Republic of the Philippines
BULACAN STATE UNIVERSITY
City of Malolos

Bid Bulletin No. 4 **Modifications in the Terms of Reference and** **Plans/Drawings**

This Bid Bulletin no. 4 is issued to modify or amend items in the Bidding Documents for project: **“Supply, delivery and installation of Intelligent Video Surveillance System for Bulacan State University Main and External Campuses (G-2022-33)”**. This shall form an integral part of the said Bidding Documents.

SITE DEVELOPMENT PLAN

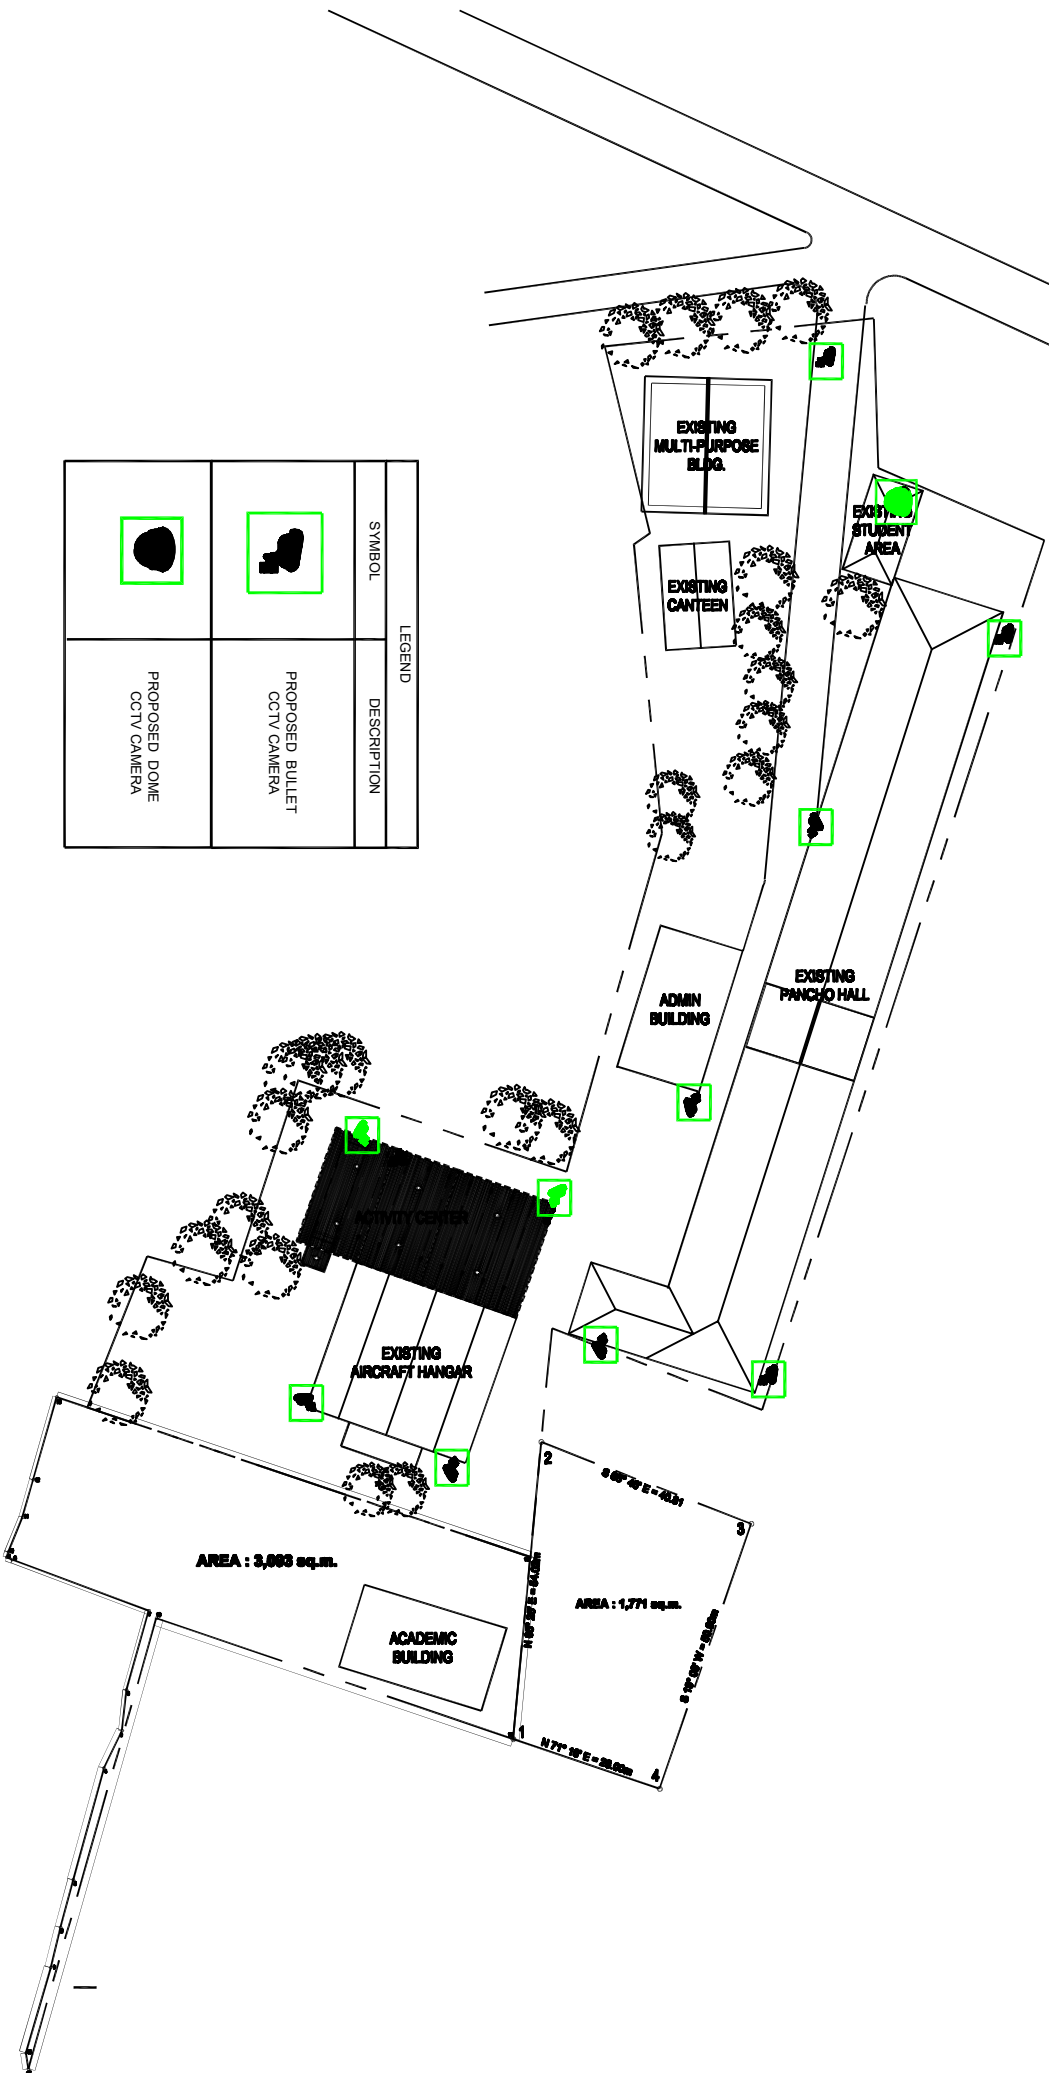
FROM					TO				
Distribution of Camera per Campus					Distribution of Camera per Campus				
Campus	Bullet type	Dome Type	PTZ Type	Total:	Campus	Bullet type	Dome Type	PTZ Type	Total:
Bustos	5	24	-	29	Bustos	10	19	-	29
					<i>Please see attached Plans/Drawings for Bustos Campus</i>
